LuK Service Info

TB2079

Part Nr: 631 1067 11 — 305mm DBFR

Manufacturer: CASE-IH

Flywheel
Schwungrad
Volant-moteur
Volante-motor
Volano

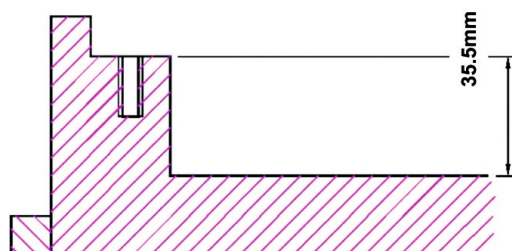
Please ensure that the flywheel is machined to a pot depth of 35.5mm.

Das Schwungrad ist auf eine Tiefe von 35.5mm auszdrehen, siehe unten.
